City of Portland, Maine – Building or Use Permit Application 389 Congress Street, 04101, Tel: (207) 874-8703, FAX: 874-8716

BUILDING PERMIT REPORT

DATE: 12/June/96 ADDRESS: 276 Brackett St
 REASON FOR PERMIT: Change Use Illegal Unit To Legal Units
 BUILDING OWNER: Dayton
 CONTRACTOR: " " " APPROVED: *4*5*7*8
 PERMIT APPLICANT: " " " DENIED: *9

* CHANGE OF USE FROM 6 UNIT
TO 4 UNIT.

BUILDING SKETCH ADDENDUM

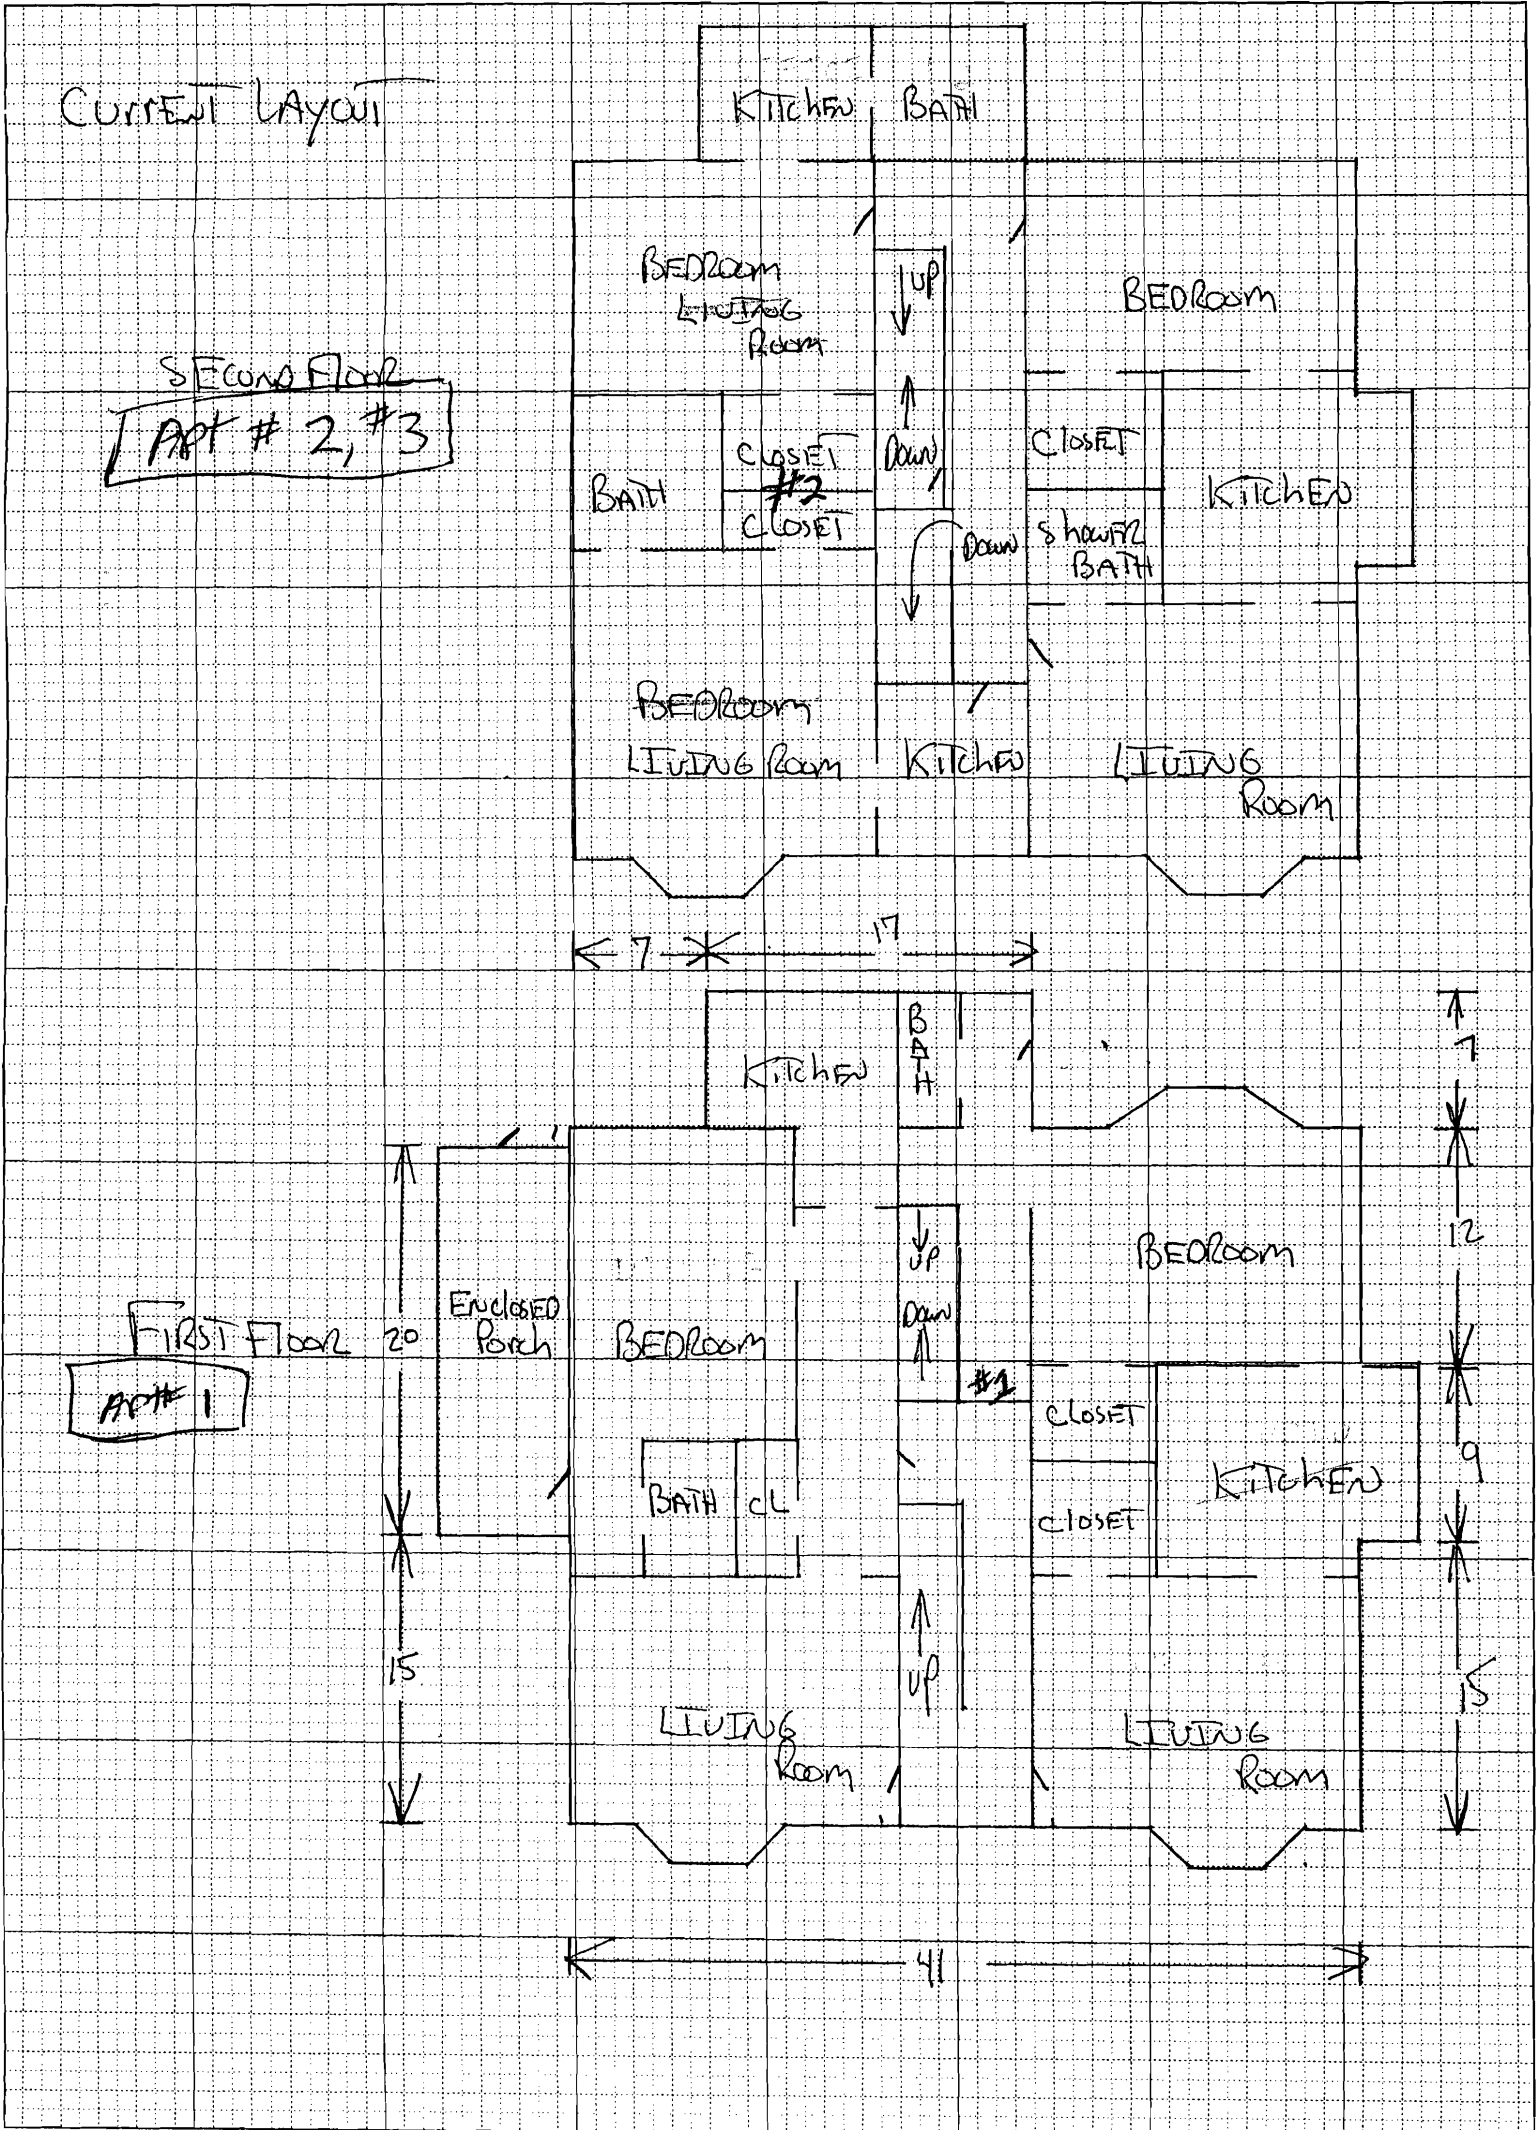
Remove PARTITION WALL IN HALLWAY
(MARKED # 1) SEE PLANS. THIS WALL WAS
NOT ORIGINAL.

Remove PARTITION WALL BETWEEN
CLOSETS - (MARKED # 2) SEE PLANS
THIS WALL WAS NOT ORIGINAL.

THIRD FLOOR
APT # 4

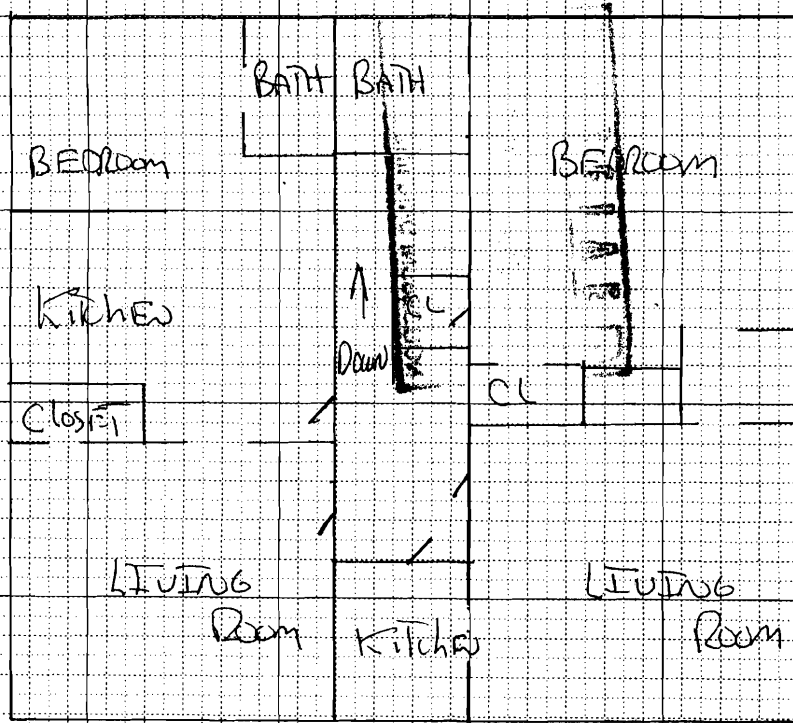
REINSTALL DOOR AT BOTTOM OF STAIRS.
